**CONTINUANCE OF HEARING FOR VACATION AND CONVEYANCE OF EASEMENT
FOR USE OF AIR SPACE OVER THE NORTH FOUR FEET OF EAST LOCUST
STREET ADJOINING 350 EAST LOCUST STREET TO
EAST VILLAGE GROWTH PARTNERS, LLC FOR \$1,000**

East Village Growth Partners LLC -
Air Rights along the north side of East Locust St west of E 4th St 11-2013-1.15

SITE PLAN 350 E. LOCUST DES MOINES, IA

TRASH ENCLOSURE

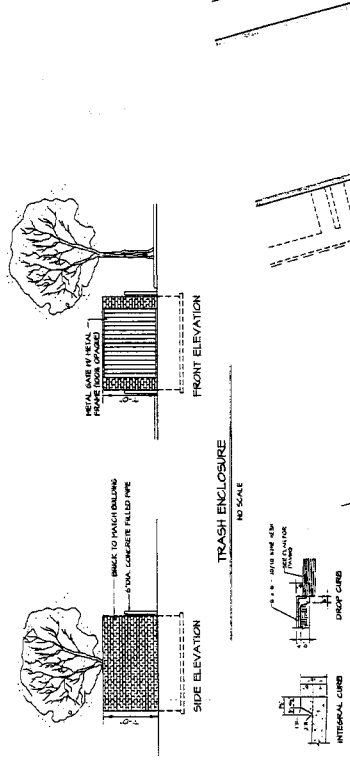
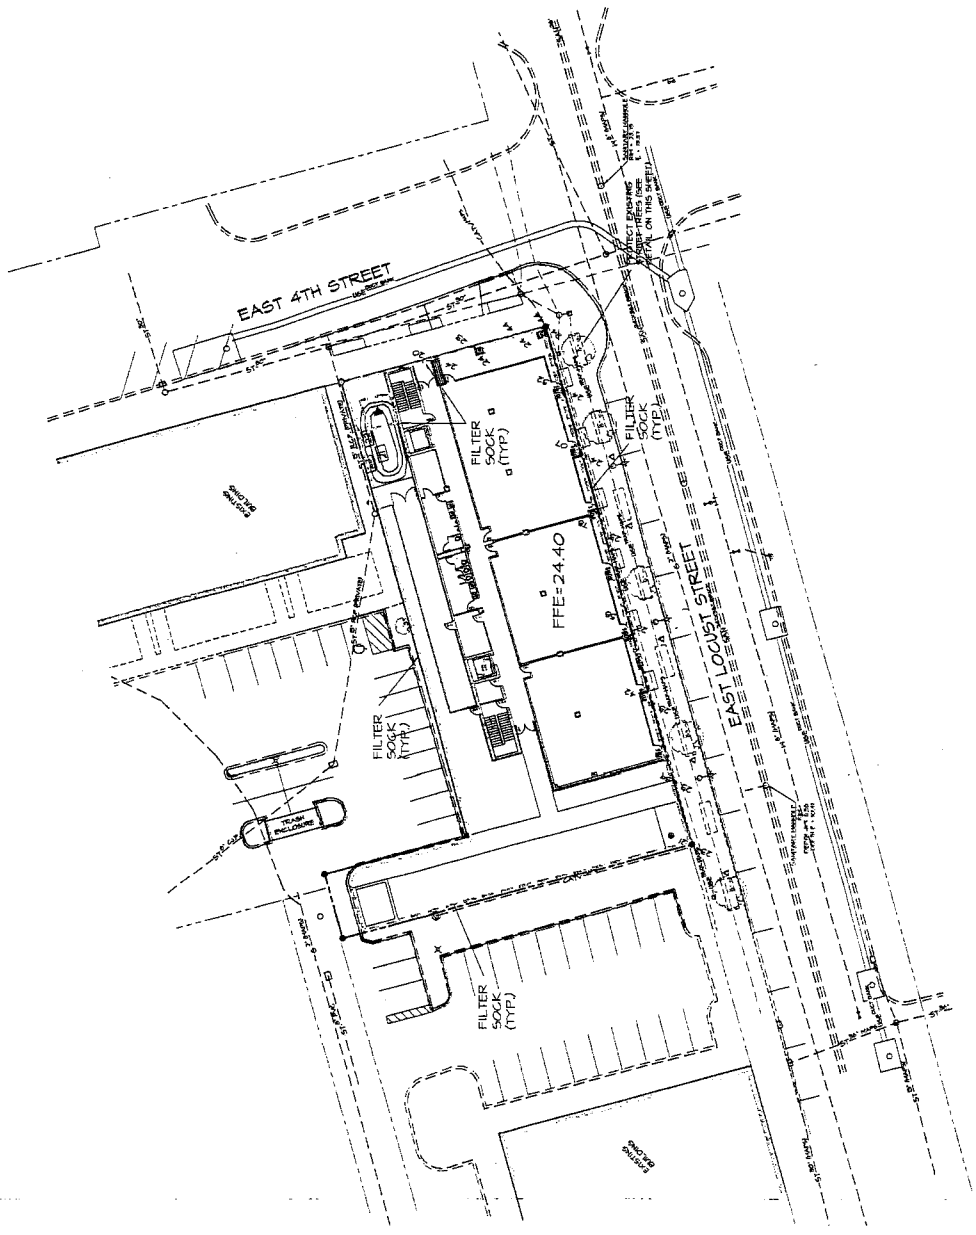
The Site Plan indicates a refuse collection container enclosure at the north end of the site that would be constructed with masonry walls to match the building and cedar gates with a metal frame. The gate must be revised to be a steel gate. Staff also recommends that this enclosure be revised to include a pedestrian access door on its east side.

1. Compliance with all administrative review comments of the City's Permit and Development Center.
2. The architecture of the building and building materials palette shall comply with any revisions required by any future review by the City's Urban Design Review Board.
3. The refuse collection container enclosure shall be constructed with steel gates and have a pedestrian access door on its east side.

Elevations_South + North

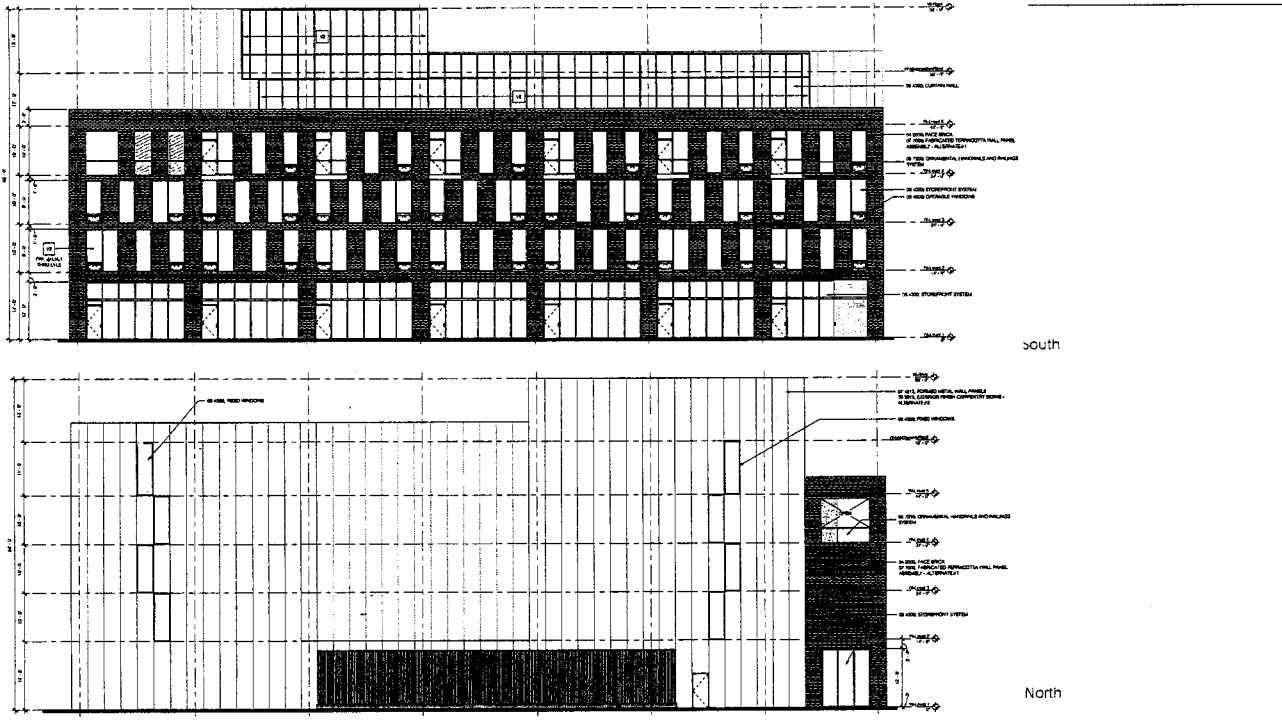
The proposed Site Plan revisions allow a balcony for each of the six (6) residential units on the 4th floor. This requires vacation of air rights for the north 4 feet of East Locust Street right-of-way adjoining the building. The proposed elevations indicate the balconies would be constructed of metal frames with glass in-fill. In order to minimize the chance of items falling from the balconies onto the public sidewalk below, the

balconies should have a rounded top railing and/or no ledge to set items on.

1. Any balcony constructed is shall generally be in accordance with the submitted building elevations and site sketch.
2. Any balcony constructed shall have a rounded top railing and/or no ledge.
